# NACIMIENTO WATER PROJECT

Addendum No. 1 to Final Environmental Impact Report

Prepared for:  
County of San Luis Obispo

Revised November 2007

**Figure 10**  
Stenner Creek Crossing

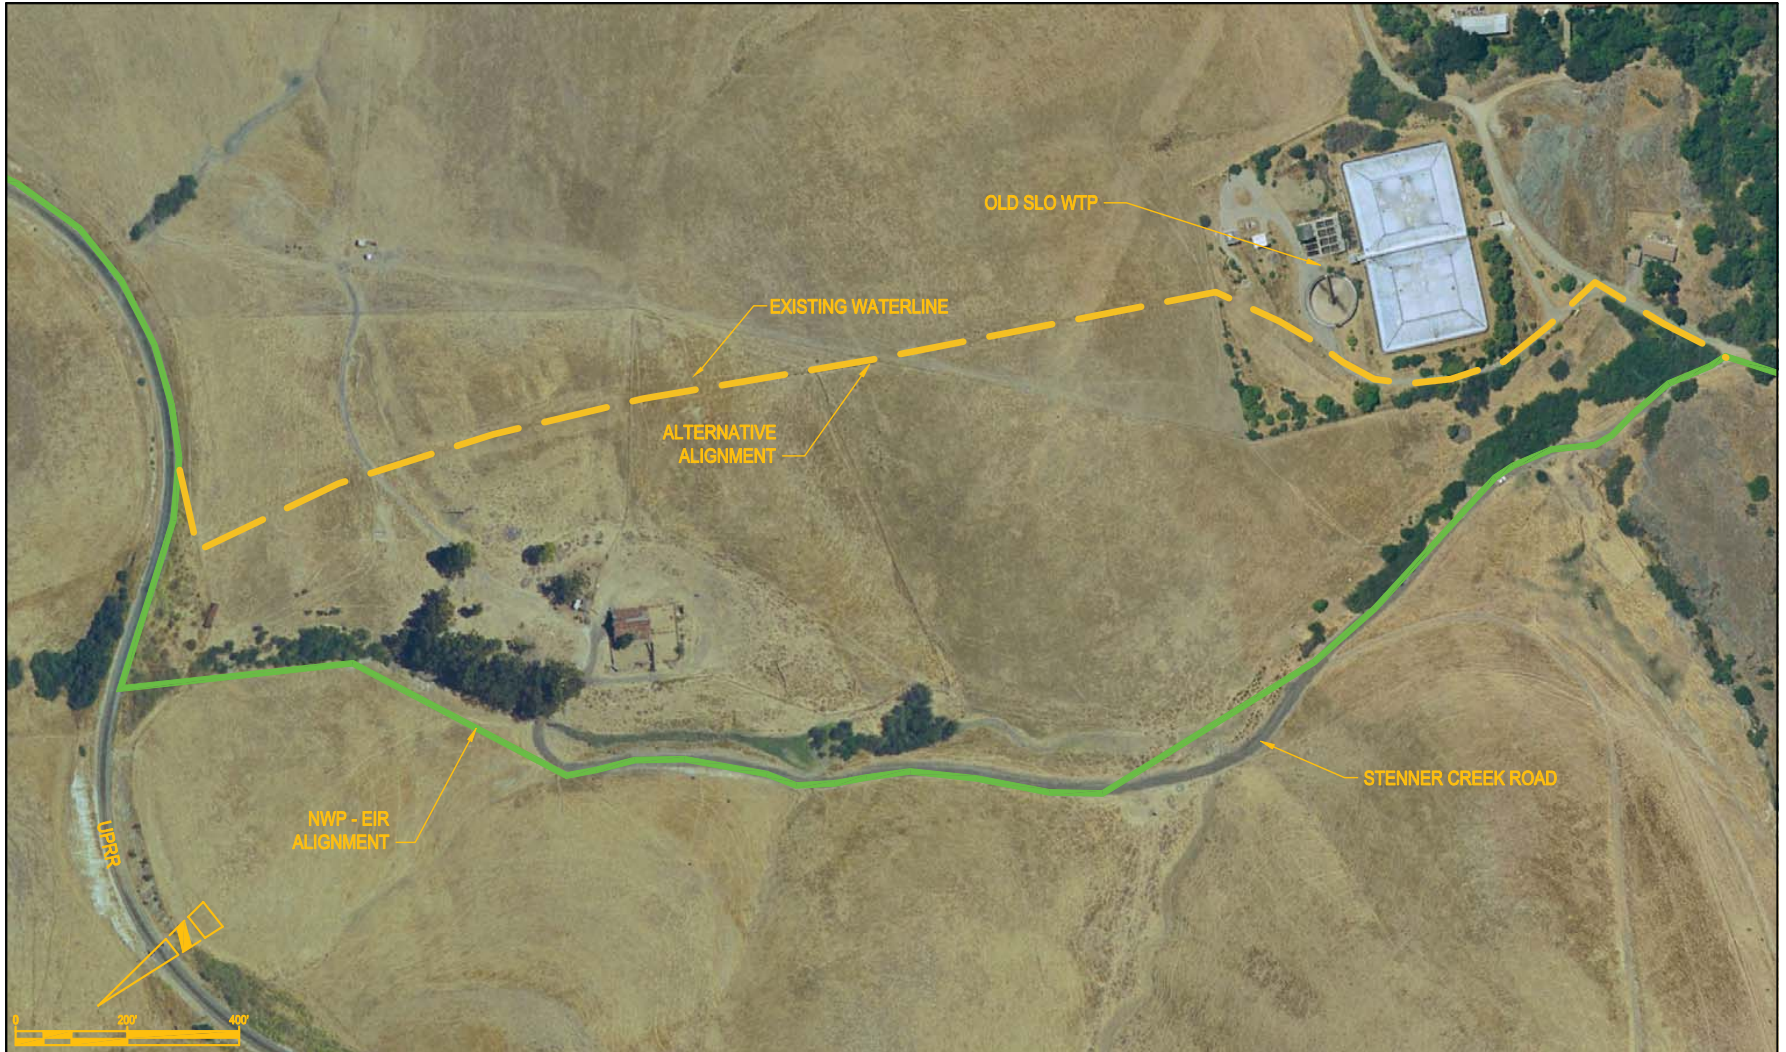
In the Final EIR, the segment of pipeline between Station 2375+00 and 2400+00 connects to the existing Nacimiento pipeline after the Cuesta Tunnel exit portal, travels downhill over open space, crosses Stenner Creek and the UPRR, and continues along the south and east side of the railroad tracks (**Figure 10**).

The proposed refinement would alter the downhill path of the pipeline through open pasture and across Stenner Creek. The refinement would result in crossing Stenner creek twice. Both crossings would be made using an above-grade suspended pipe that would be parallel to existing suspended pipes for the State Water Project and the Salinas Project in the same location. The proposed refinement would also change the location of the railroad crossing.
